EPA-430/9-77-009
Construction Grants Program
Information

VALUE ENGINEERING

CASE STUDIES AND FORMATS FOR PROPOSALS AND REPORTS

**A SUPPLEMENT TO THE VALUE ENGINEERING
WORKBOOK FOR CONSTRUCTION GRANTS PROJECTS**

PRE-VE PROJECT
LEBANON, OREGON

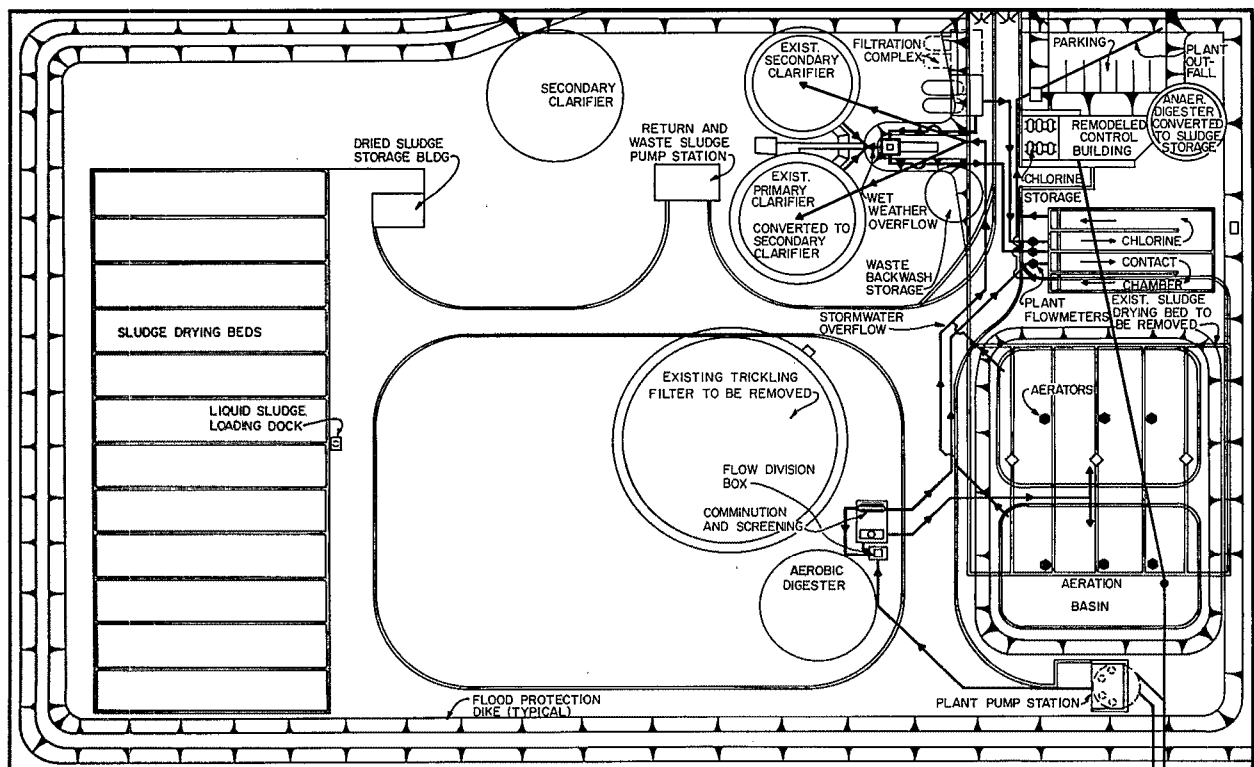
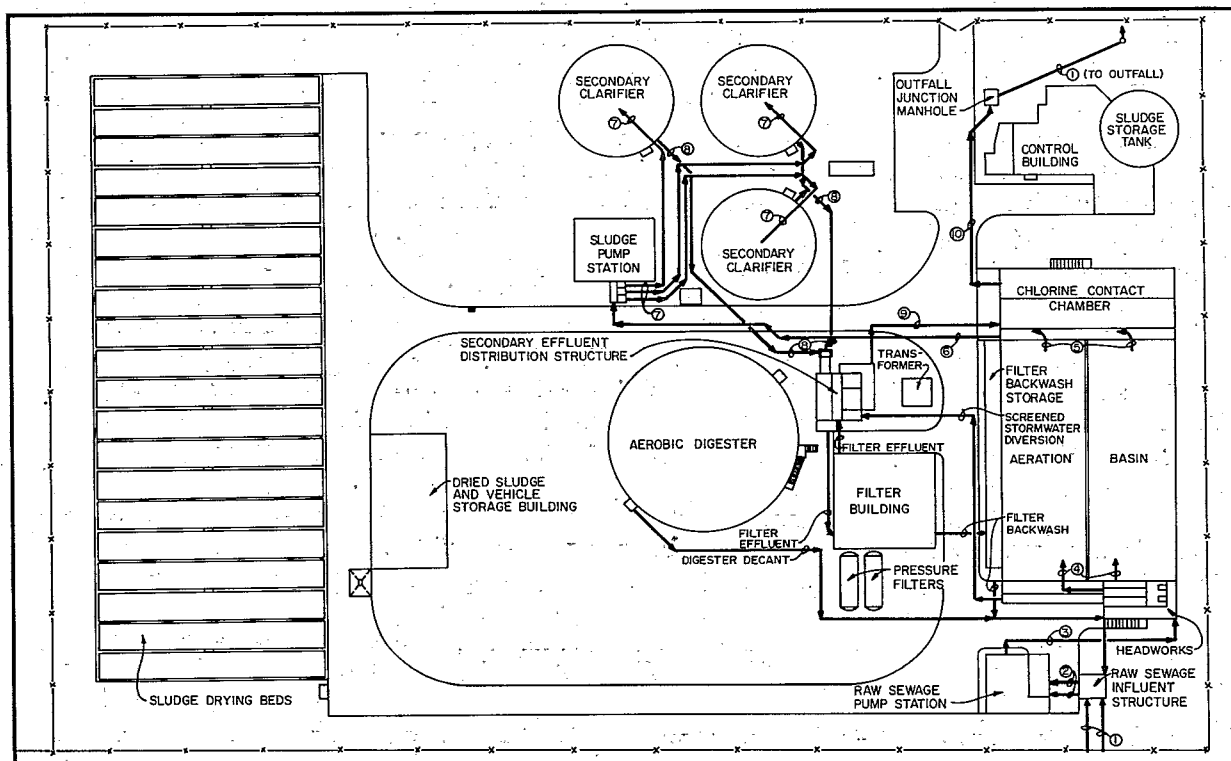
Table 4 presents the VE ideas which were accepted by the design team. Costs to implement the VE changes were not defined but were considered "minimal" because there was little impact on already completed design work. No delays resulted. The DEQ accepted the proposed changes although they did request automated freeze protection for any outdoor pumps. Figure 3 presents the post VE layout of the plant.

About 50% of the projected savings from the VE study were related to the repositioning of the chlorine contact chamber. The raising of the contact chamber requires pumping of secondary effluent to the chamber at all times. The DEQ remains uncertain as to whether or not the added power and

FIGURE 9. MAIN PUMP STATION & FORCE MAIN REVISION

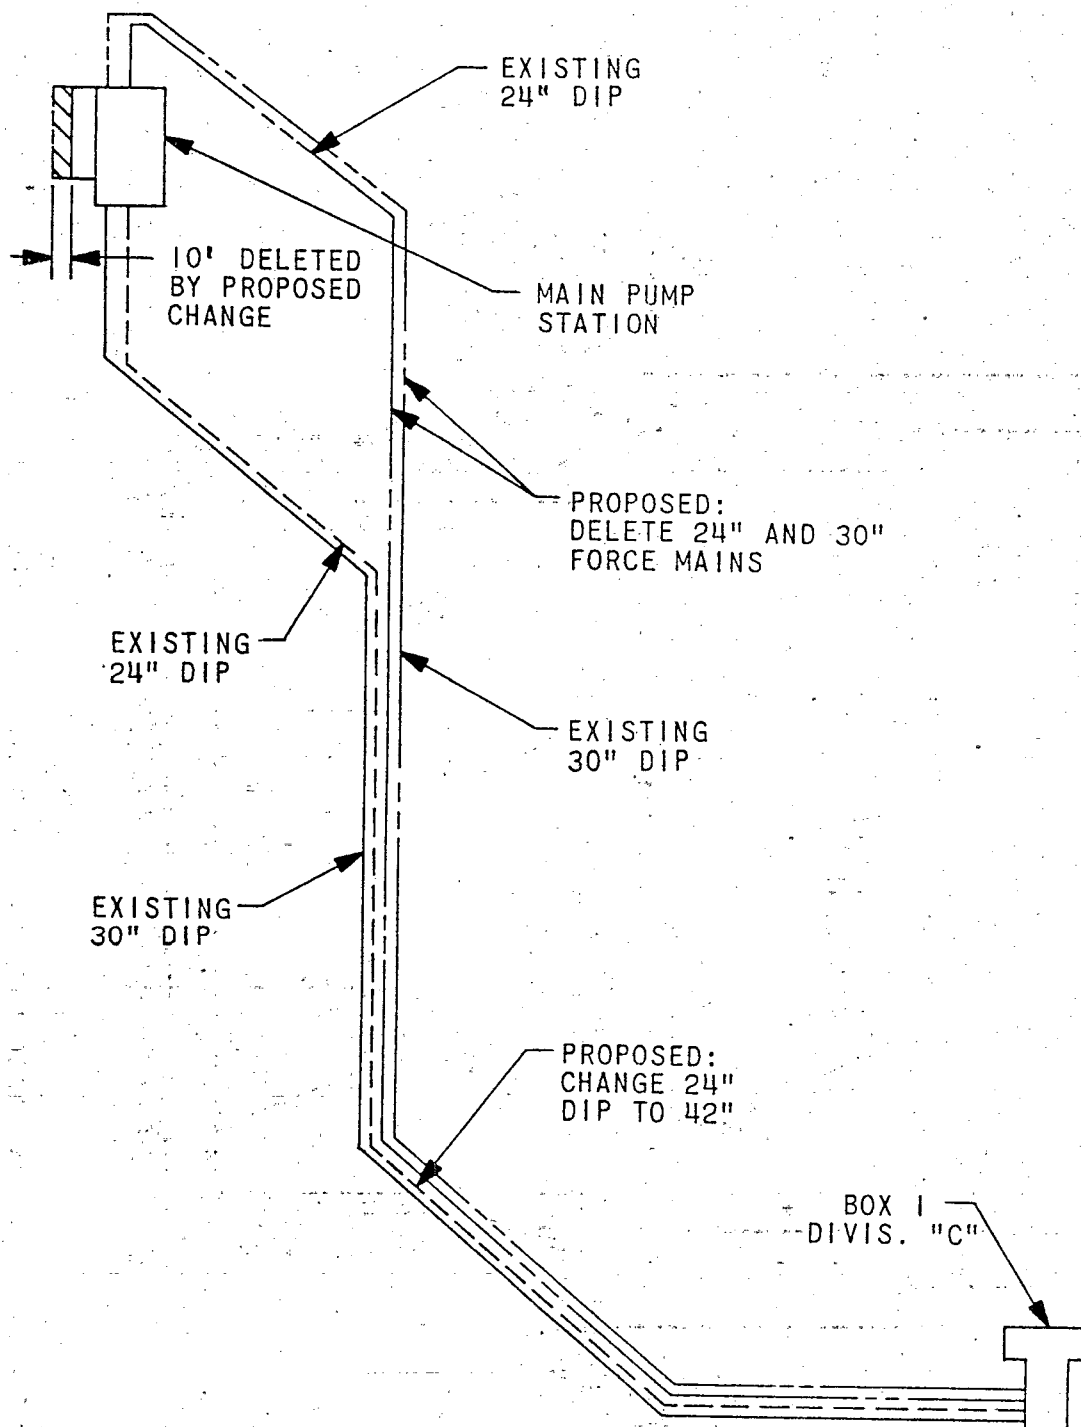
1. Figure 9. Main pump station. The design had two 24 inch and two 30 inch mains. Proposed eliminating one 24 inch and one 30 inch force main. Of the two remaining mains (24 and 30 inch), changed the 24 inch to a 42 inch main.

2. Figure 9. The main pump station had two constant speed and two variable speed pumps. The VE team proposed using all variable speed pumps thereby reducing the size of wet well. Result is a reduction in size of the pump station from 70 feet by 70 feet to 70 feet by 60 feet.

FIGURE 10. MAIN PUMP STATION UTILIZING ROCK FOR FOUNDATION

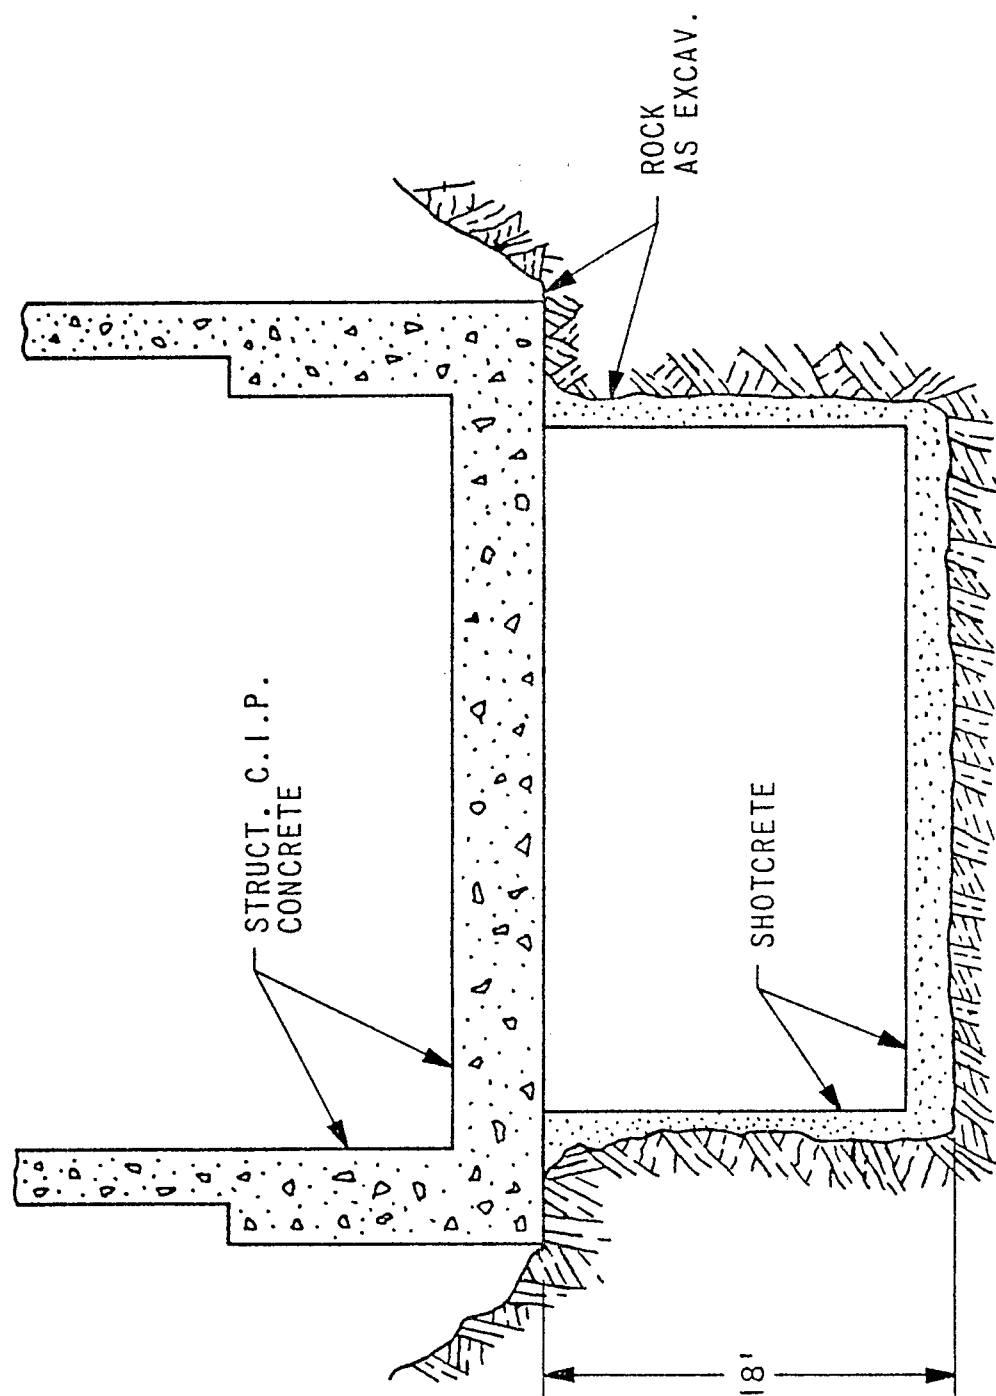
3. Figure 10. Main pump station. The VE team proposed constructing the lower 18 feet by excavating and utilizing the rock faces for floors and walls and using shotcreting facing. Also, decreased the excavation of site by 4.5 feet.

FIGURE 11. PUMP STATION ENCLOSURES

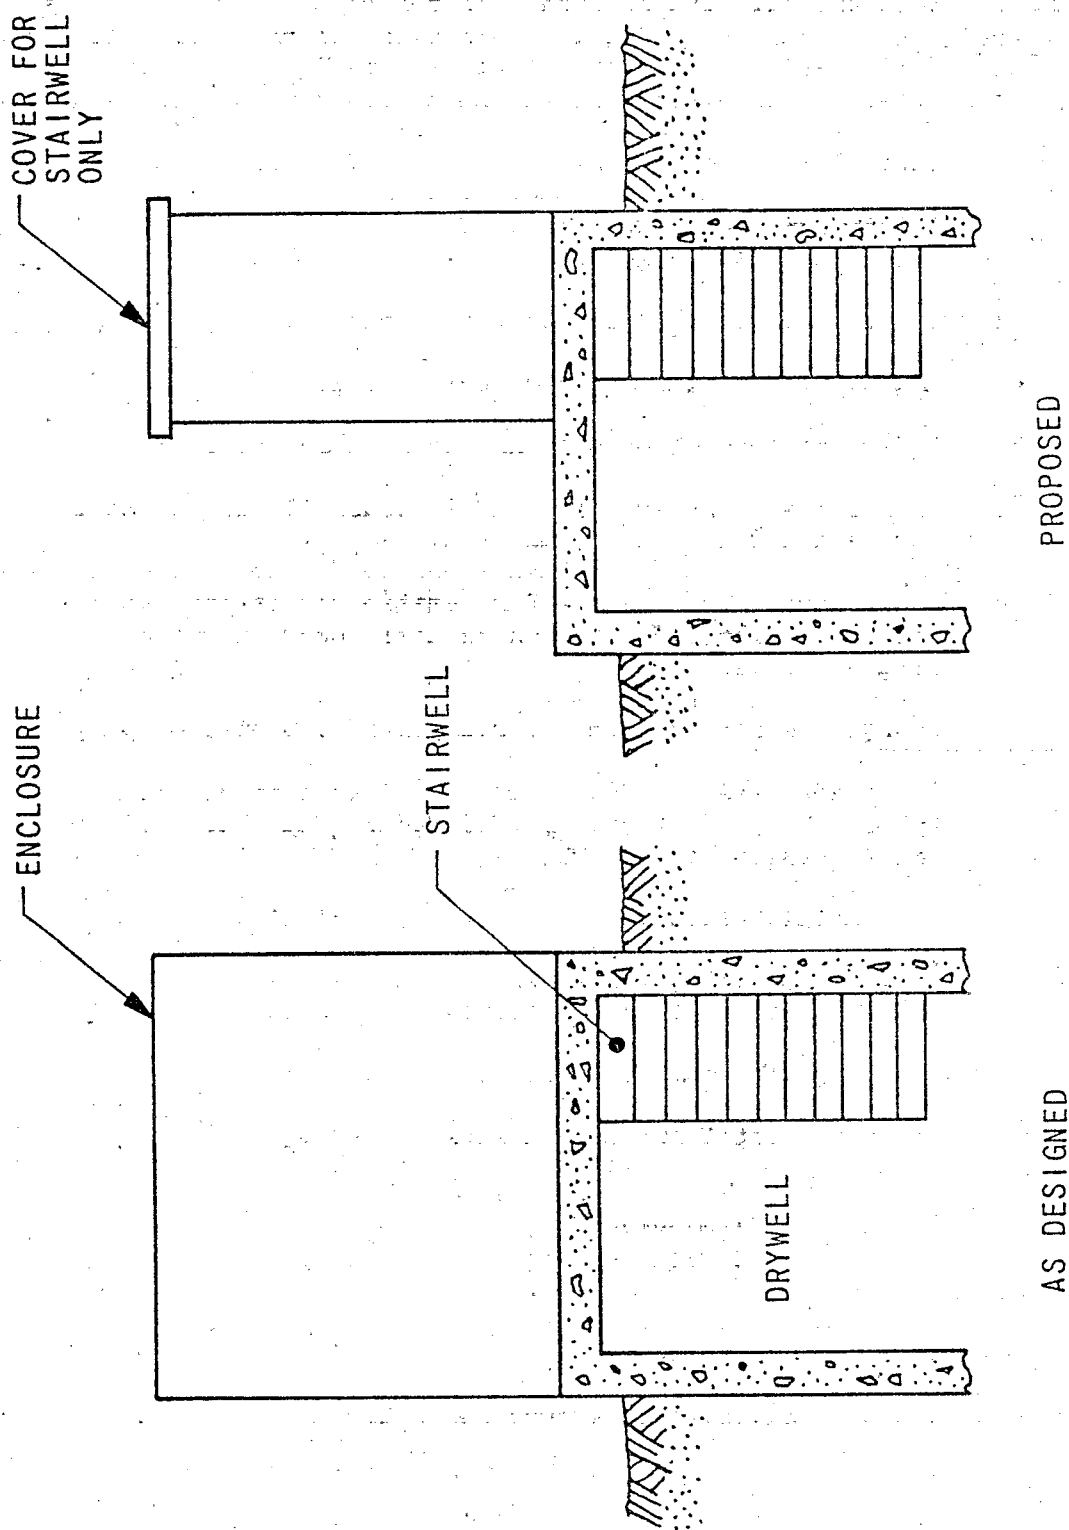
4. Figure 11. Eliminated above ground enclosure over all four pump stations except for stair well enclosure.

FIGURE 12.
ASH BASIN-AS DESIGNED

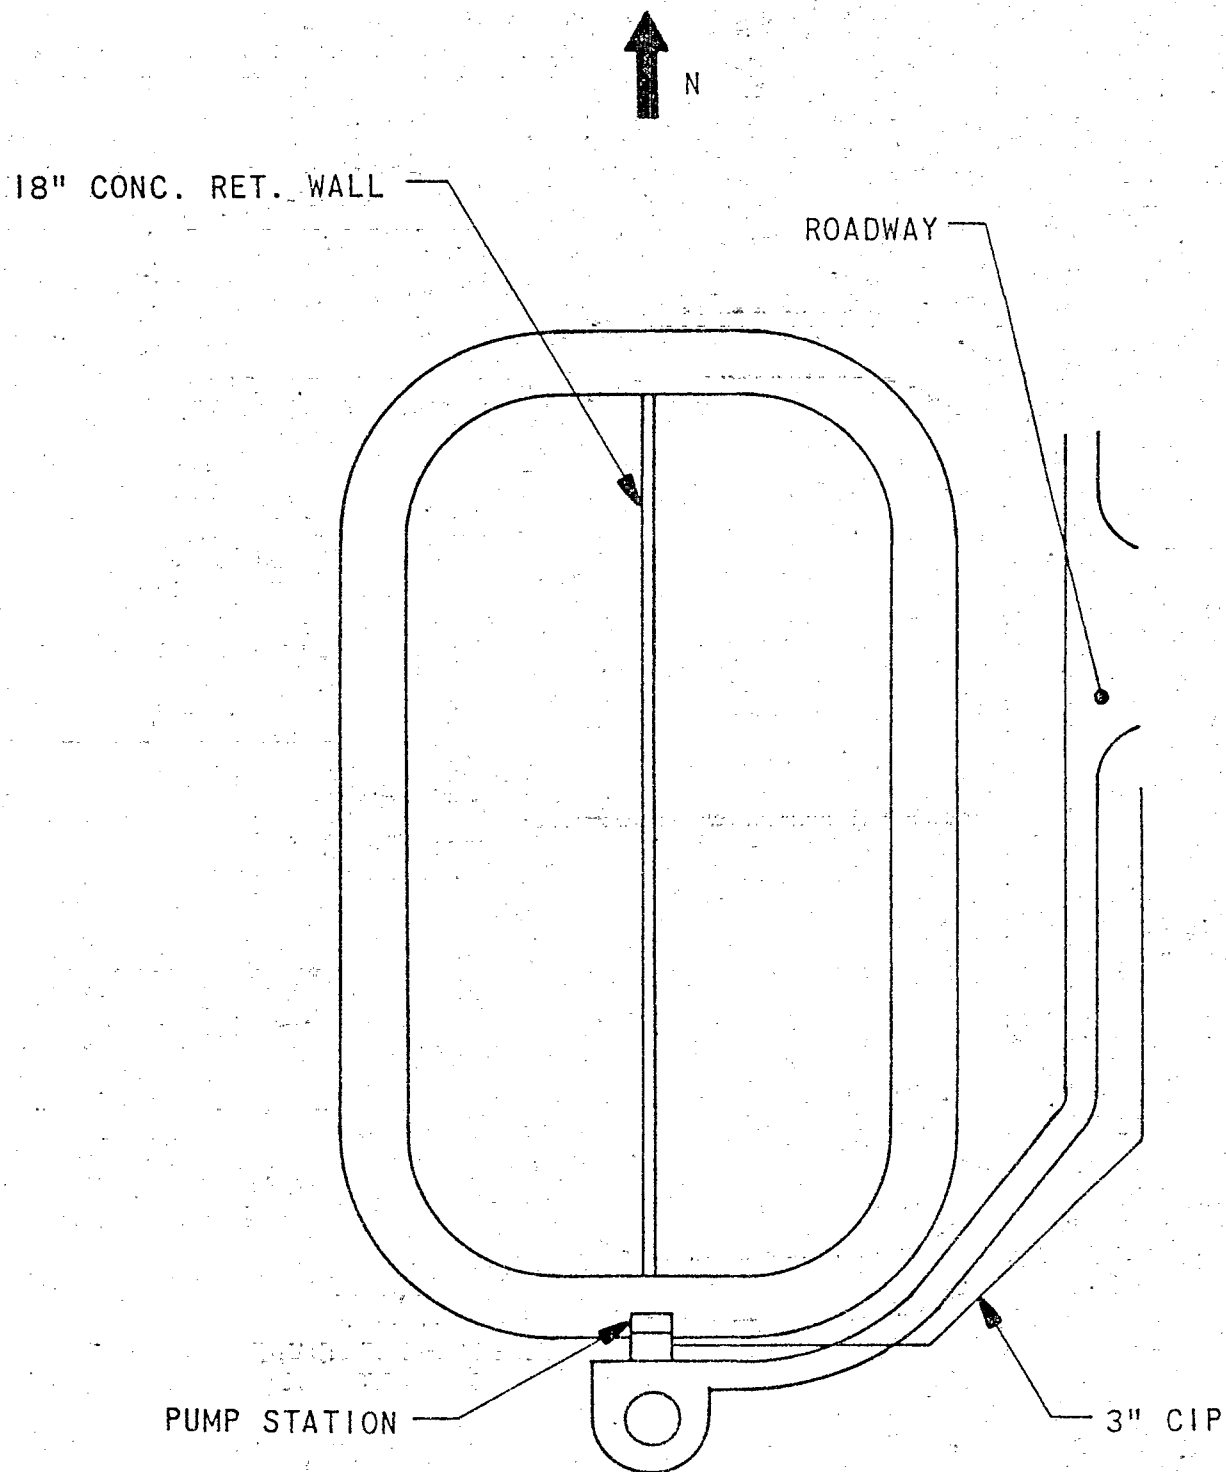
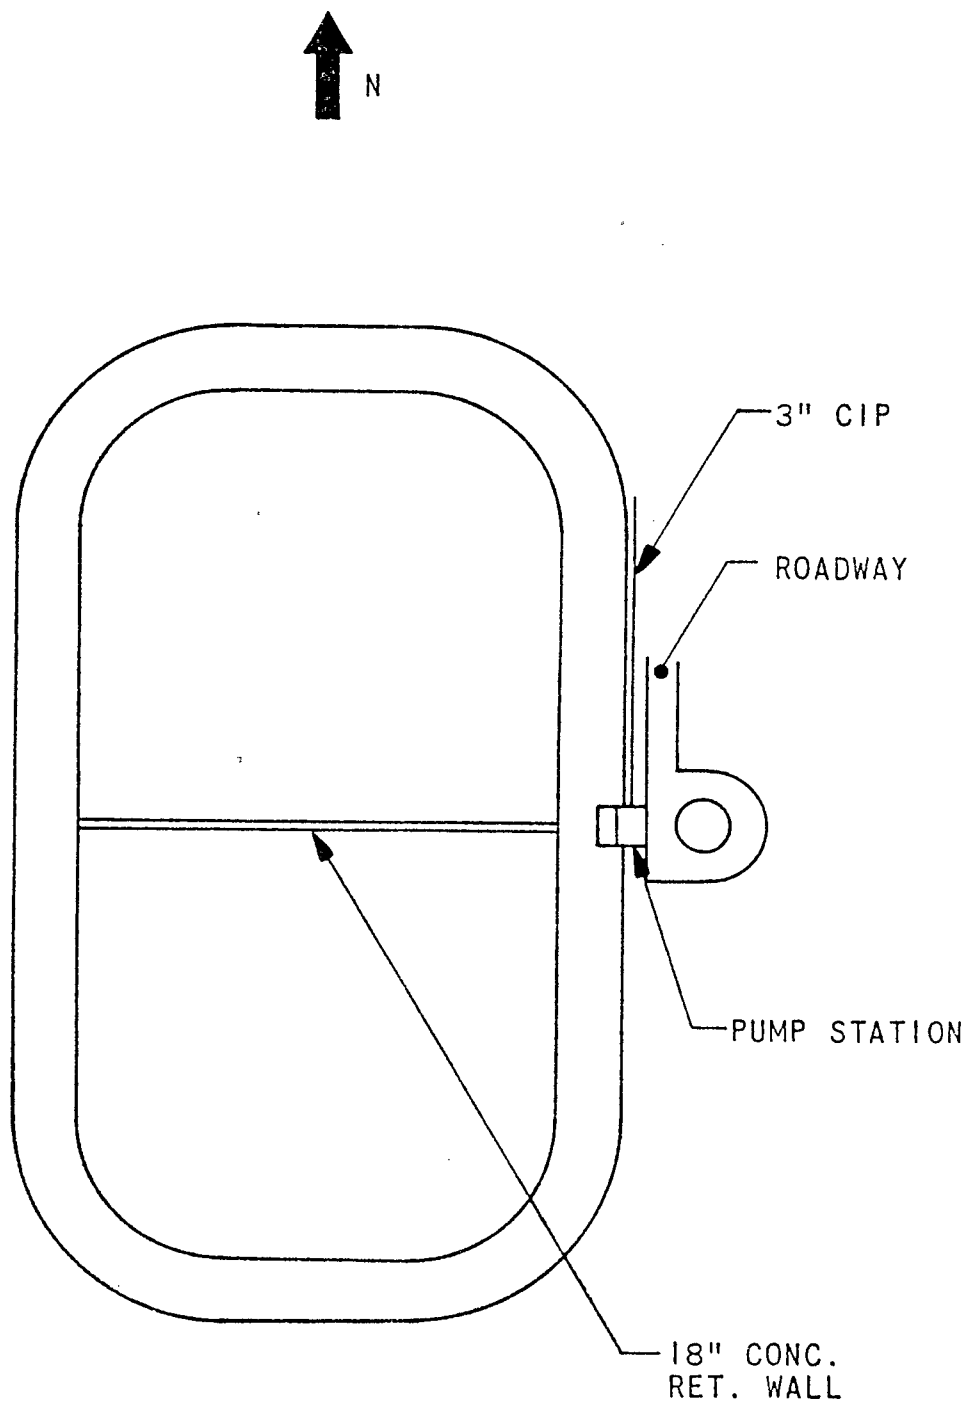
5. Figure 12 and 13. The 18 inch concrete retaining wall in the ash basin ran lengthwise. The team proposed changing the wall to run across the basin width. This would shorten the wall, road, 3 inch pipeline and electrical wiring and conduit to pump station.
